New Albany Architectural Review Board Meeting Agenda

ARB-75-2023 Certificate of Appropriateness

Architectural Review Board Staff Report August 14, 2023

153 EAST GRANVILLE STREET EXTERIOR MODIFICATIONS CERTIFICATE OF APPROPRIATENESS

First Floor Plan Sakasci Diamonds

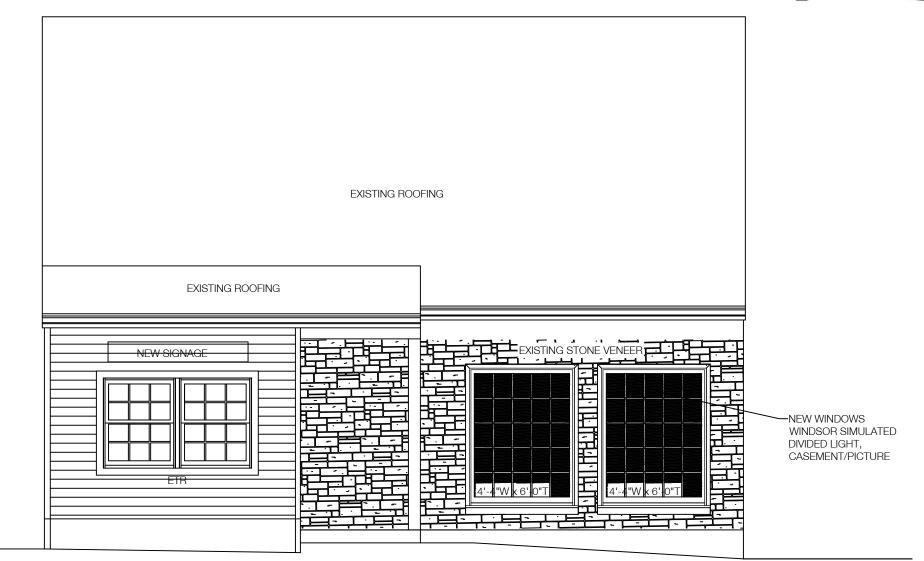
- The new single-story addition will be constructed on top of an existing, elevated porch at the rear of the building. The existing building materials include horizontal vinyl lap siding and stone veneer on a portion of the front elevation. The applicant proposes to remove the vinyl siding and replace it with new 6" white hardie plank lap siding.

- The applicant proposes to install seven new casement/picture style windows with a simulated divided light feature on the building addition. The simulated divided light grid pattern used for these windows differs than those on the primary building. The city architect states that the differentiation in the grid pattern is acceptable in this case as it provides an appropriate delineation between the addition and the existing structure.

Front Elevation

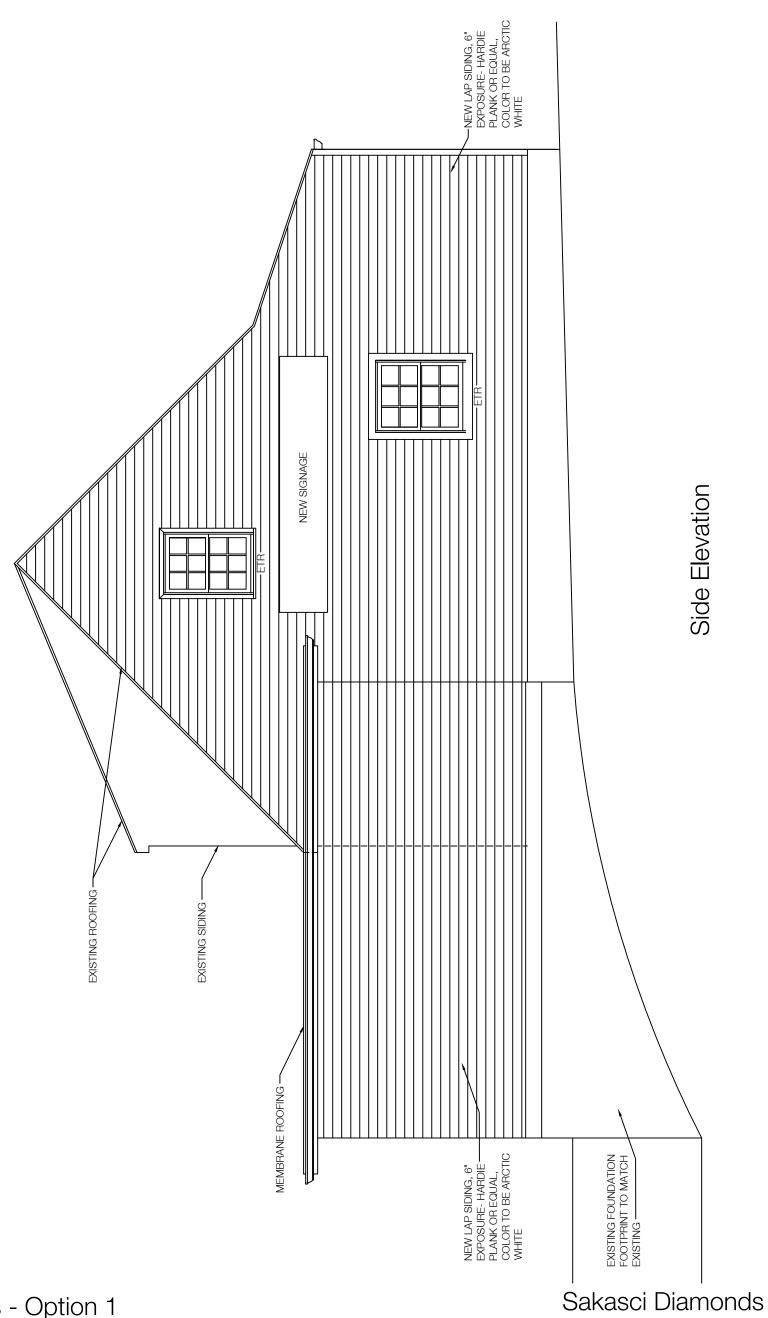
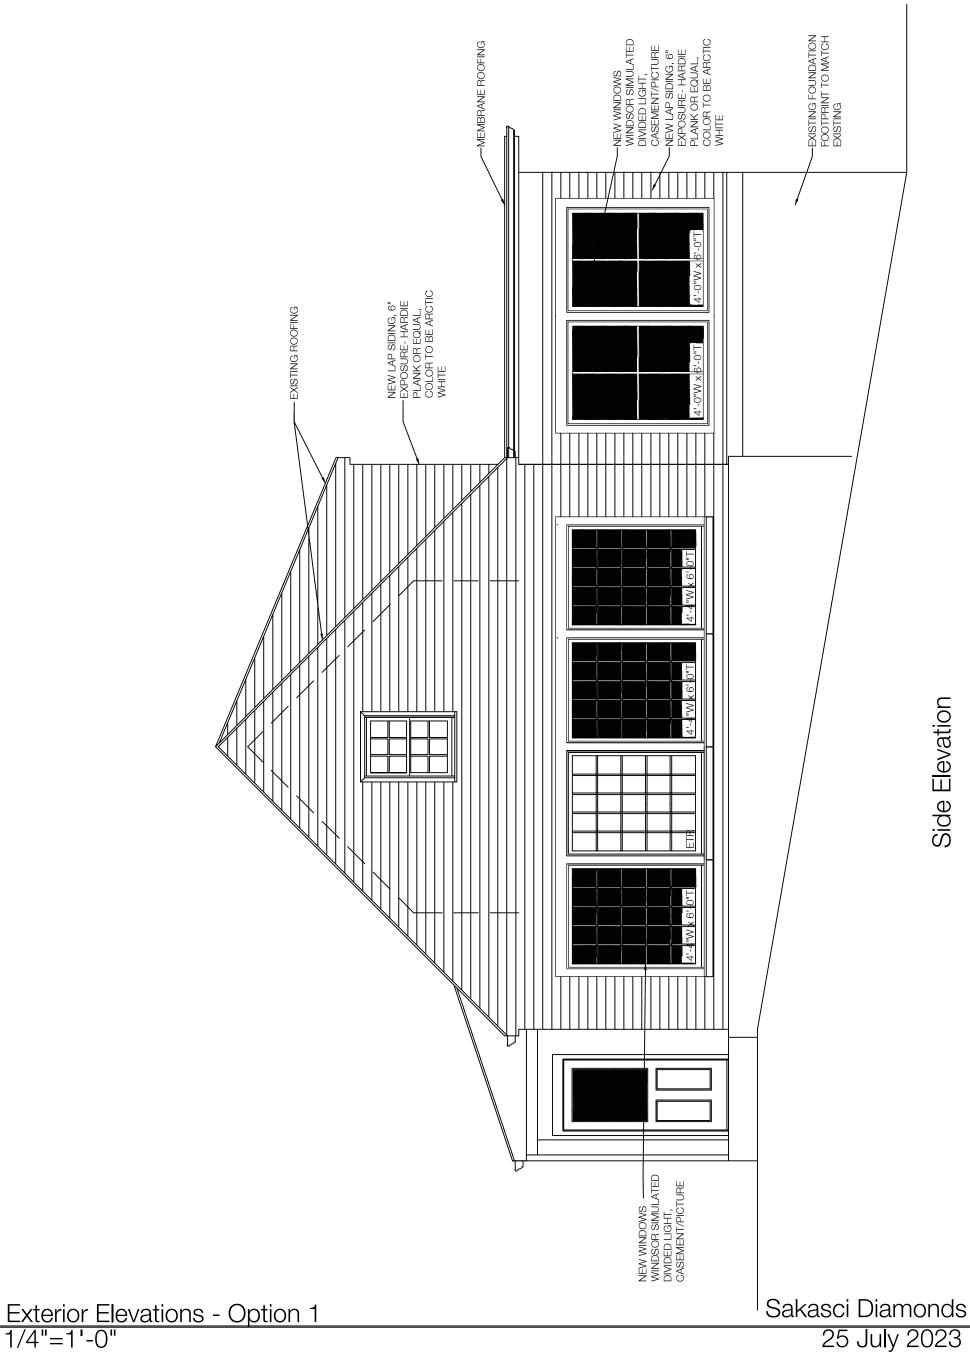
- O Stone veneer is currently used on a portion of the front building façade and around the front door. The applicant proposes to relocate the front door to a different portion of the front building façade. The applicant proposes to use stone veneer in place of the existing door location so that the building material is consistent on that portion of the elevation.

- DGR section 3(II.B.2) states that the orientation of main building facades, those with primary entrances, shall be toward the primary street on which the building is located. The applicant proposes to relocate the front door or the building to face the western side yard therefore this requirement will not be met. The board should evaluate the appropriateness of relocating the front door. If the board determines that is appropriate, a waiver is necessary.

- All existing double hung windows will remain on the building with the exception of one on the front building elevation which is to be replaced with two larger casement/picture windows with a simulated divided light feature, matching the existing window on the western building elevation.
